Value Engineering Study Report
– Final

I-69 Ohio River Crossing Project
Evansville, IN and Henderson, KY

August 2, 2019

Idea Title	Modify Veterans Memorial Parkway interchange
Function	Support Redundancy

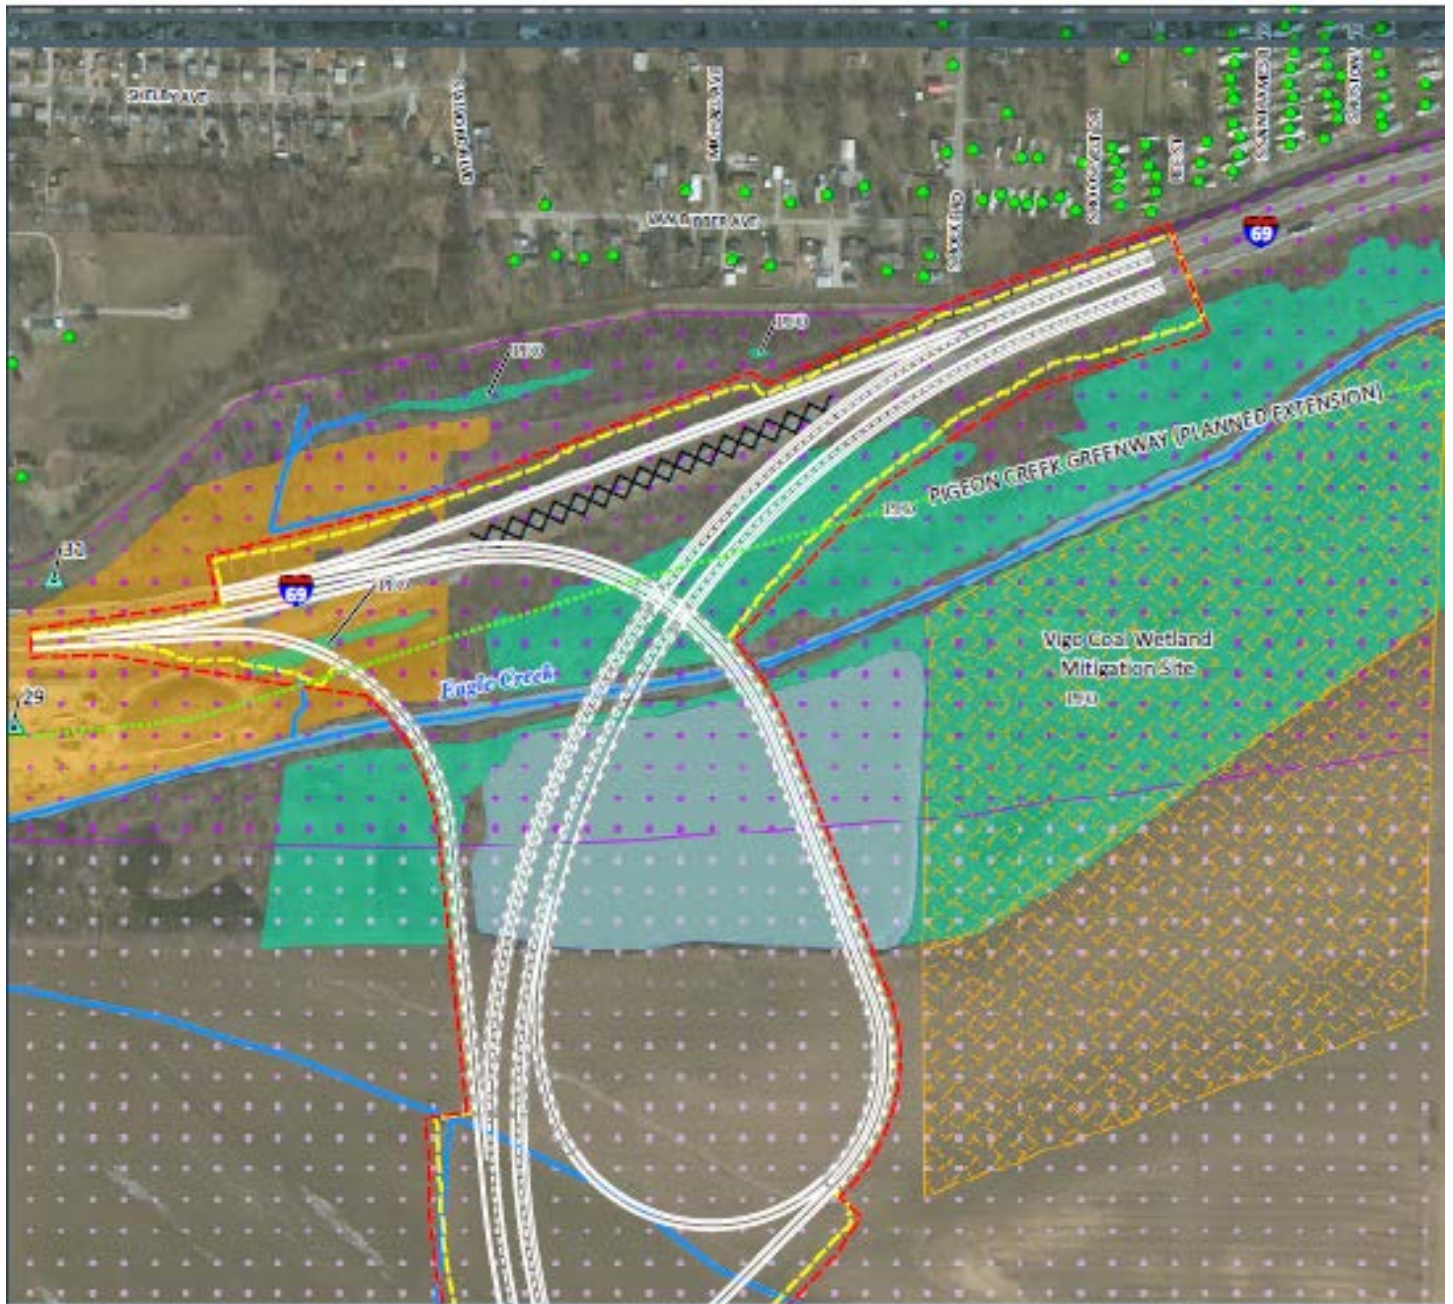
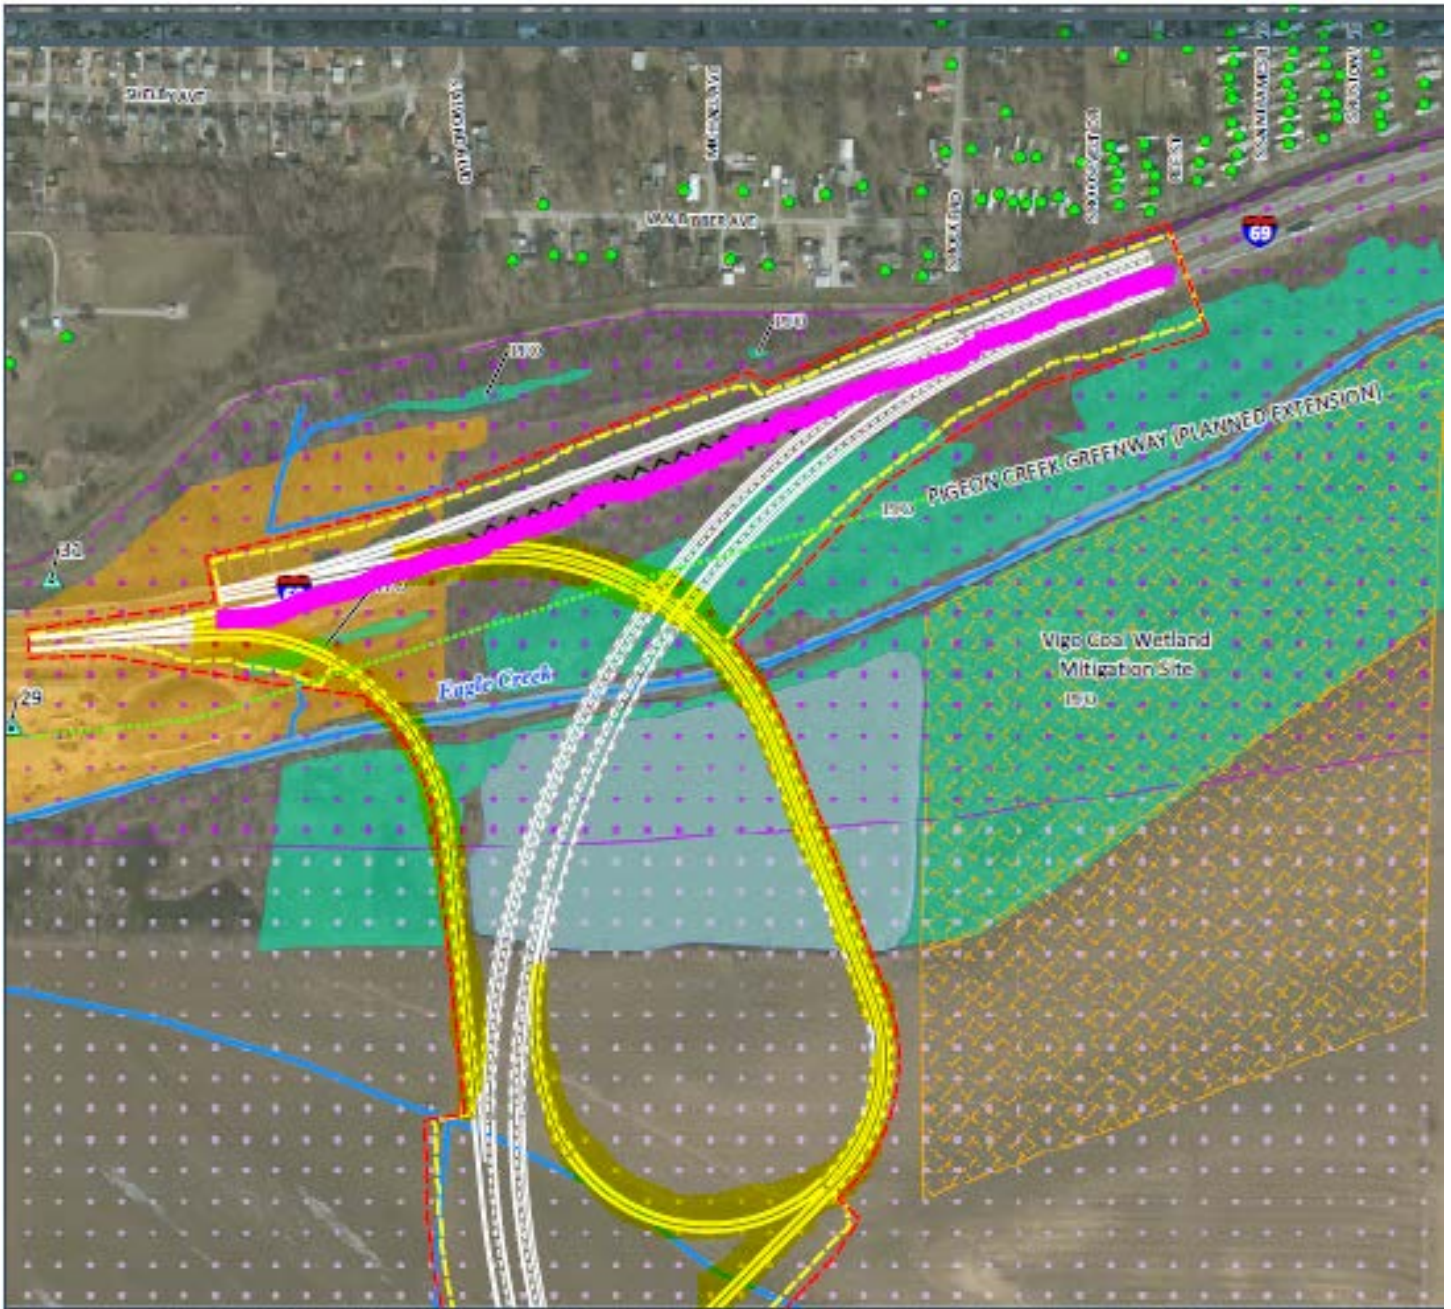
Provide full access to Veterans Memorial Parkway from new I-69 interchange.

Delete access from east bound Veterans Memorial Parkway to southbound I-69 and northbound I-69 to westbound Veterans Memorial Parkway. Maintains east-west connectivity along Veterans Memorial Parkway.

FHWA approval of a new partial interchange on the interstate system may be difficult.

Idea Title	Remove KY2084 ramp southbound
Function	Support Redundancy

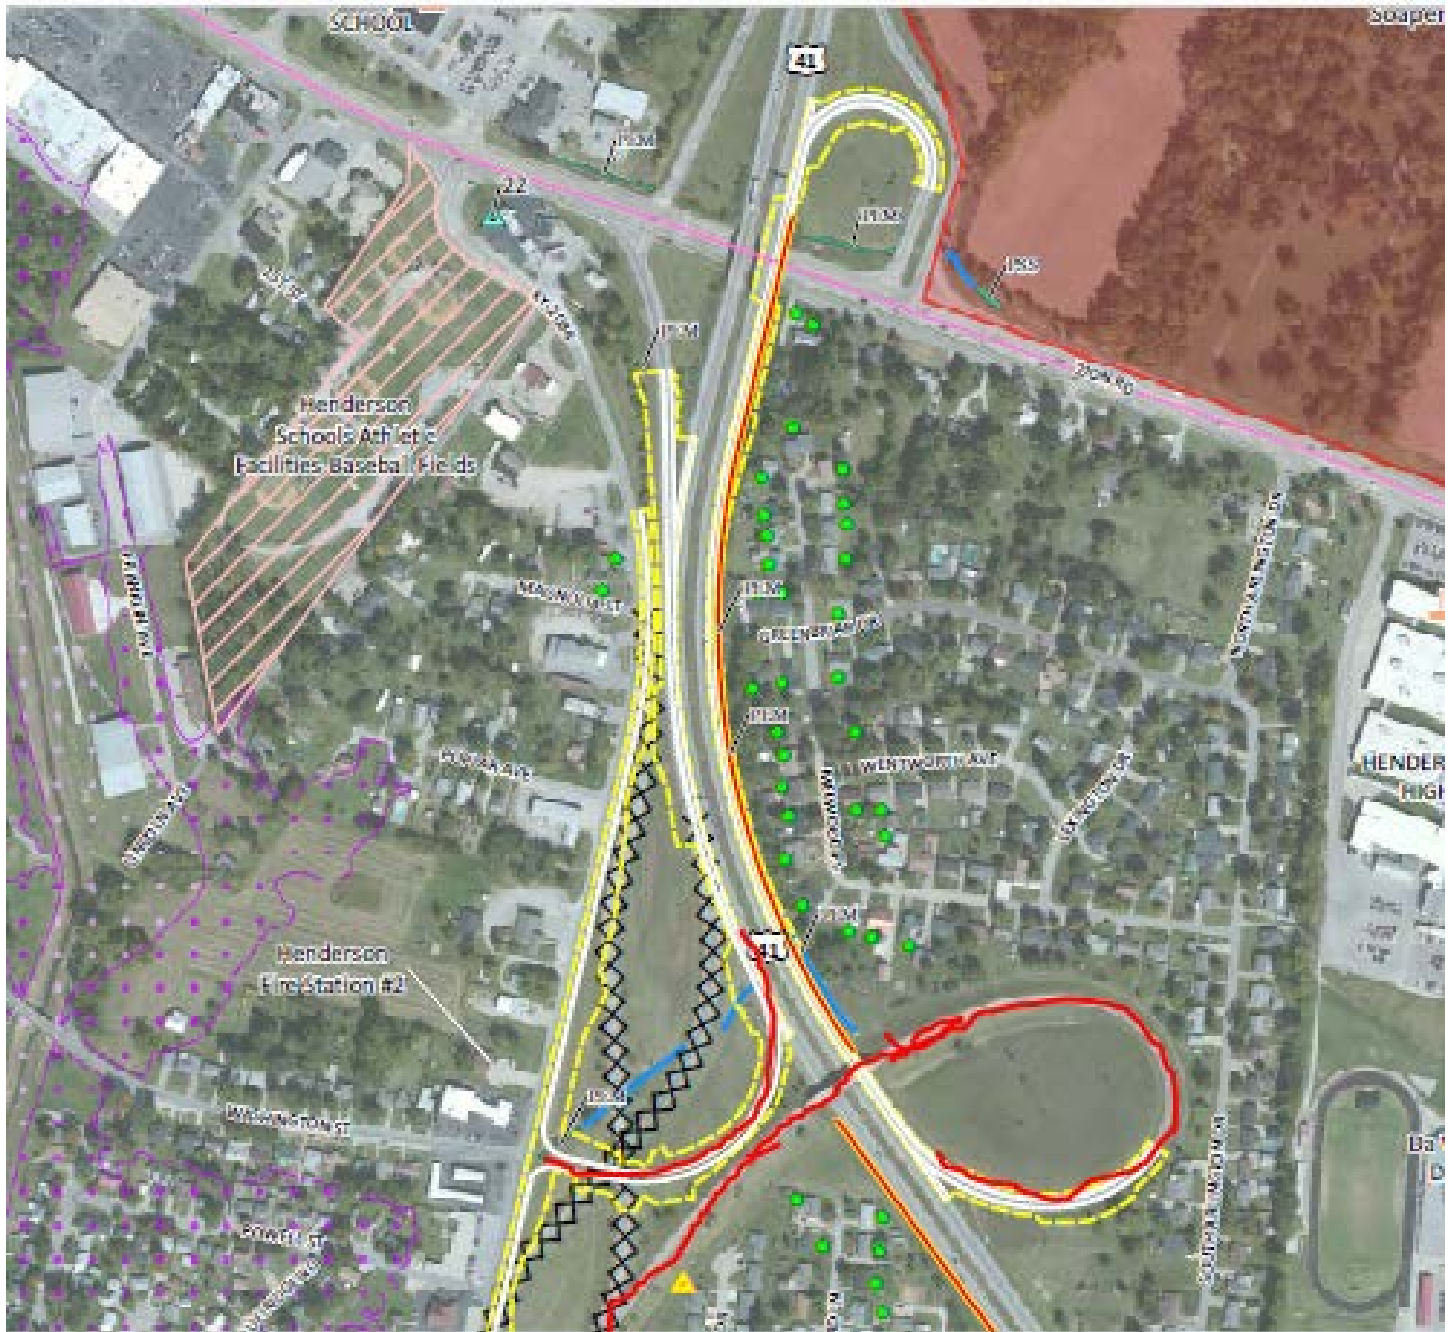
ORIGINAL CONCEPT:
 Proposed design removes existing US 41 southbound off ramp to KY 2084 southbound and new construction of a US 41/I-69 southbound ramp terminating with KY 2084 at a T-Intersection. KY 2084 northbound ramp onto US 41 northbound/I-69 has no significant change to current in-place geometry. Widened a section of KY 2084 to two lanes north of the existing southbound off ramp from US 41 southbound.

ALTERNATIVE CONCEPT:
 Remove the interchange of KY 2084 with US 41/I-69. This interchange is in close proximity with the current and proposed interchange with KY 351/2nd Street.

Remove KY 2084 interchange with US 41/I-69. This interchange is less than ½ mile from the KY 351/2nd Street interchange. Removal of KY 2084 interchange increases safety along the corridor due to the extreme close proximity of interchanges thereby reducing traffic movements/weaving within this short distance. Current interchange has minimum traffic volume compared to the immediate northern and southern interchanges. Impact to motorist is minimum, approximately one mile increase in distance to access US 41/I-69.

Idea Title	Investigate alternate location for eastern crossing
Function	Support Redundancy

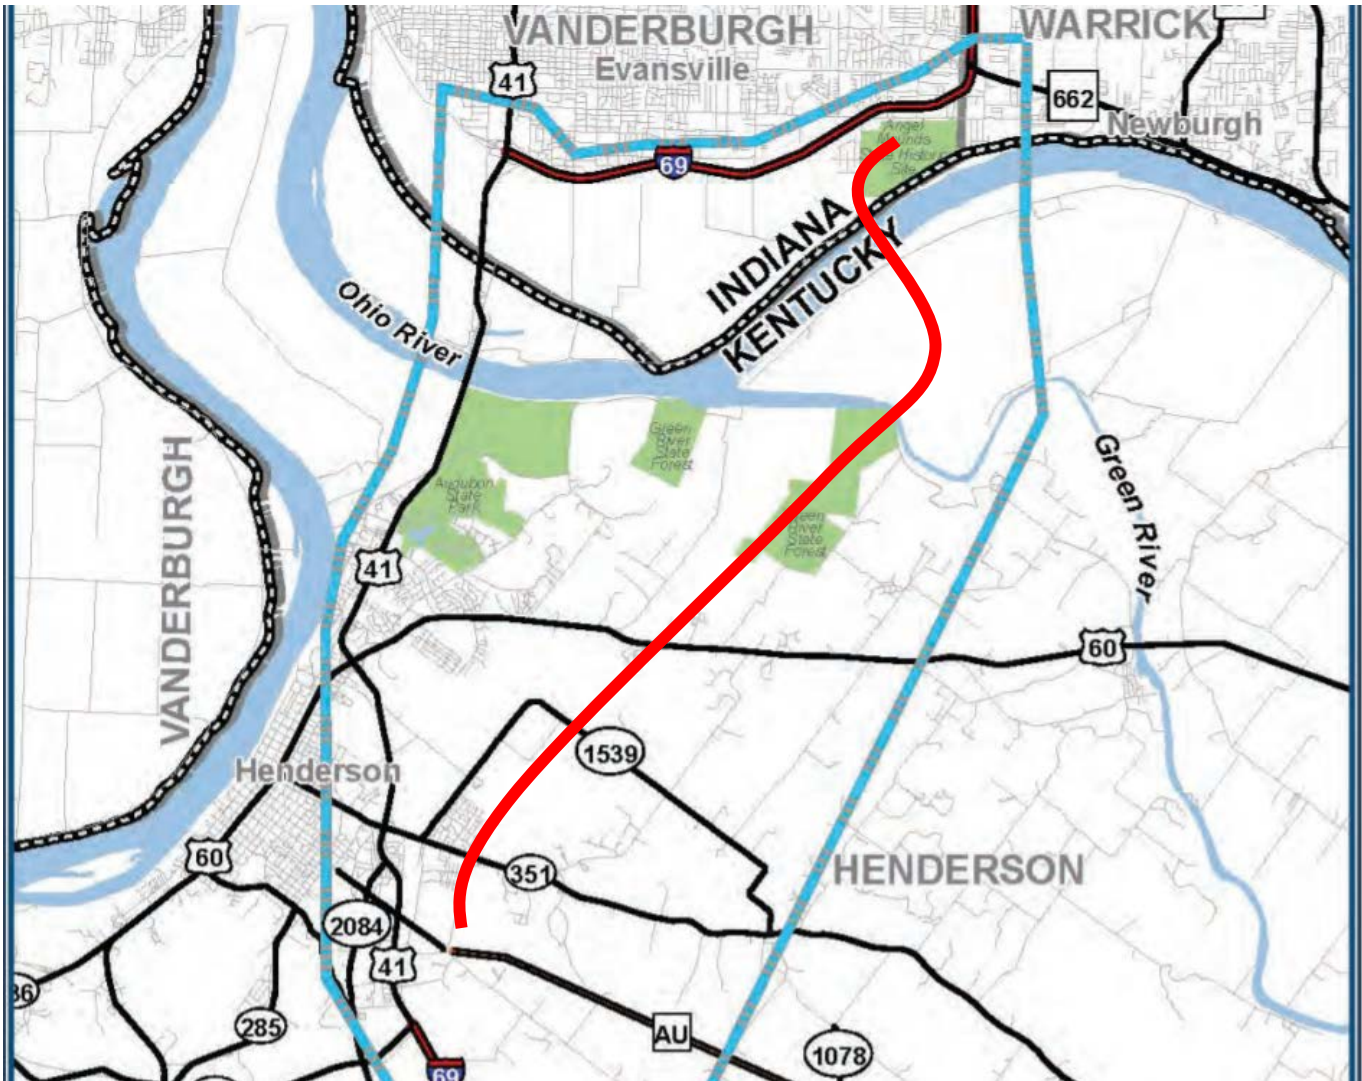
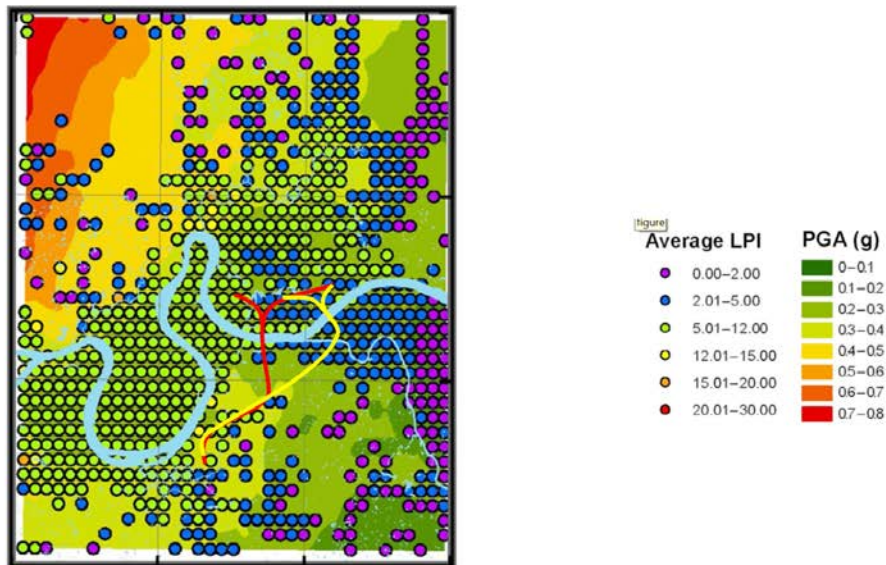
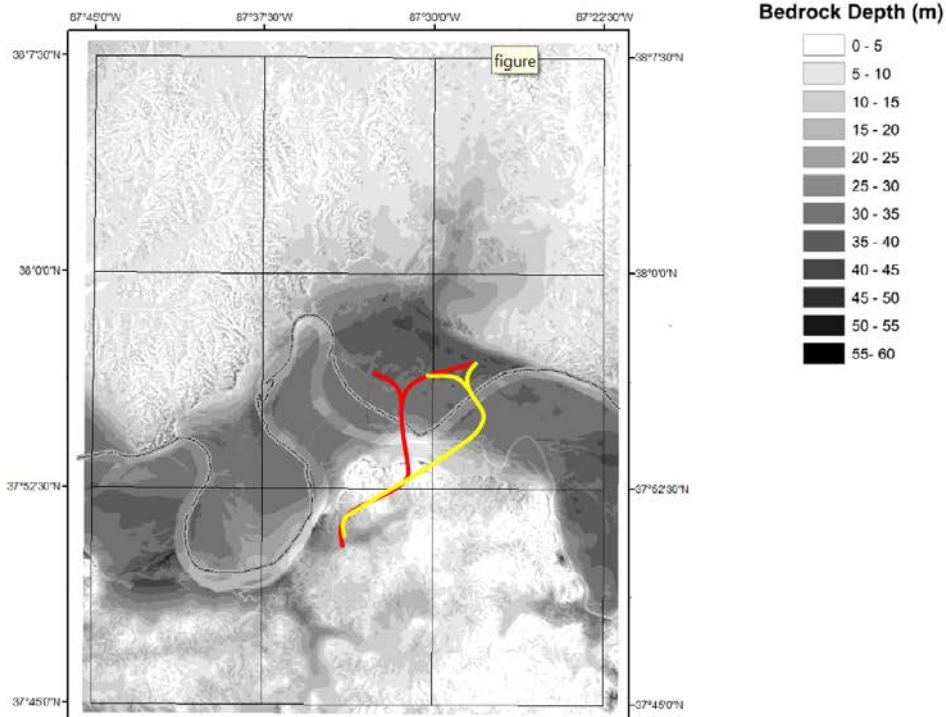
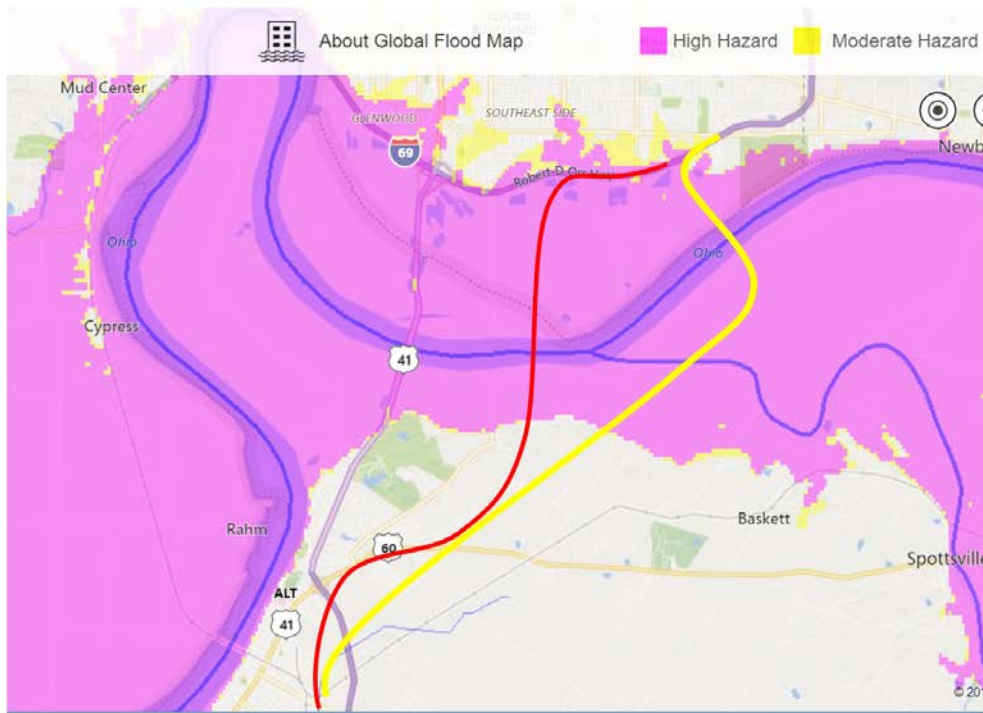
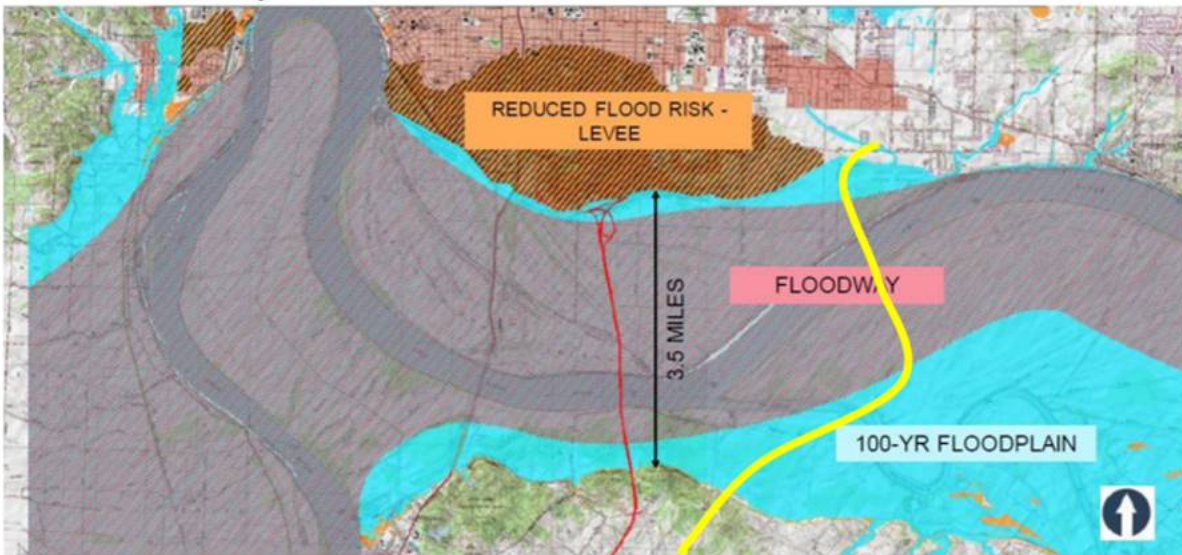
The alternative concept modifies the location of the east crossing to span the Ohio River just to the west of the Angel Mounds Site. This requires a separate crossing of the green river and splits the two Green River Forest parcels but avoids all the Indiana residential relocations in the eastern corridor and significantly reduces right of way costs. A primary benefit of this alignment is that it reduces to the extent possible, the portion of the river crossing over Indiana and therefore reduces the hydraulic impacts where Indiana has more stringent requirements.

This alternative is a modification to the east corridor alternative, with the alignment shifted to the west of the Angels Mounds State Historic Site. More importantly, it moves the river crossing to a location in the river where there is no bend, and moves the crossing away from the confluence of the green river, where there is significant fleeting and loading/unloading activity. This location will substantially reduce the likelihood of vessel collision risk, and with a navigation simulation, likely reduce the requirements for main span length. The overall length of the water crossing, as well as the total area of bridge in the floodplain, is not significantly different from the central corridor.

Also, there has been a liquefaction lateral spreading risk assessment for Evansville completed by Purdue University, which highlights the sensitivity of the Indiana floodplain to liquefaction and lateral spreading. This can negatively impact foundation costs (these impacts could be significant depending on degree of lateral spreading and liquefaction). A liquefaction risk potential map has been included with the central and proposed eastern alignment overlaid to give a sense of relative risk. As an aside, the existing US 41 bridge alignment is in the worst part of the corridor, and in a seismic event for historic structures not designed to resist seismic loads. Significant damage to the existing bridge in a major seismic event is likely.

Depth to sound bedrock also correlates with foundation costs for major bridges, and the proposed easterly alignment puts a significant portion of the bridge in areas where bedrock is relatively shallow which should reduce foundation costs and construction schedule / risk.
